Service Manual Temporary Revision

For
M830-00-200

Index Of Temporary Revisions For M830-00-200

Number	Date	Details	Add To Manual
M830-00-200/1	17/07/98	correction to T835 RSSI circuit description	after page B2.10
M830-00-200/2	17/07/98	correction to T835 regulator fault finding chart	after page B5.12
M830-00-200/3	17/07/98	correction to T835, T836 & T837 microcontroller circuit diagrams	after pages: B6.2.26 C6.2.24 C6.3.24

There is one correction to the Regulator fault finding chart in Section 5.7.2 in Part B, as shown below.

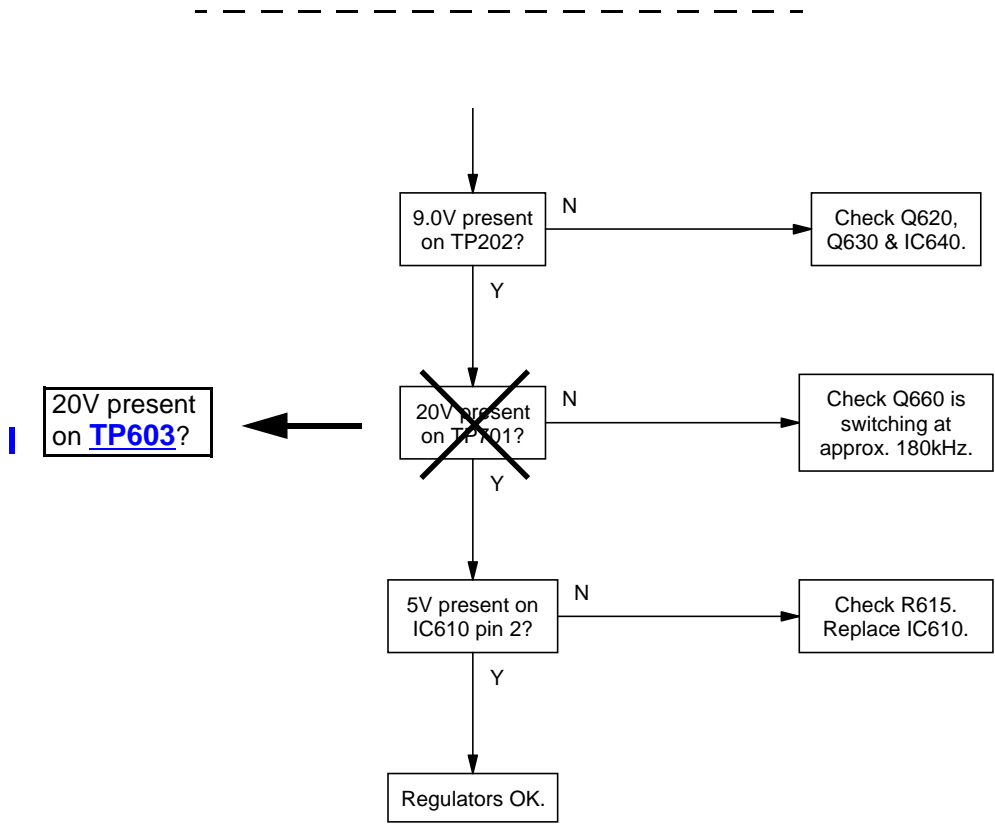
The flow chart box with the error is crossed out, and the correct text is shown alongside it.

The corrected text is underlined and in bold type, and is also marked by a vertical line. If you are viewing this document as a pdf file, the correction will appear in blue.
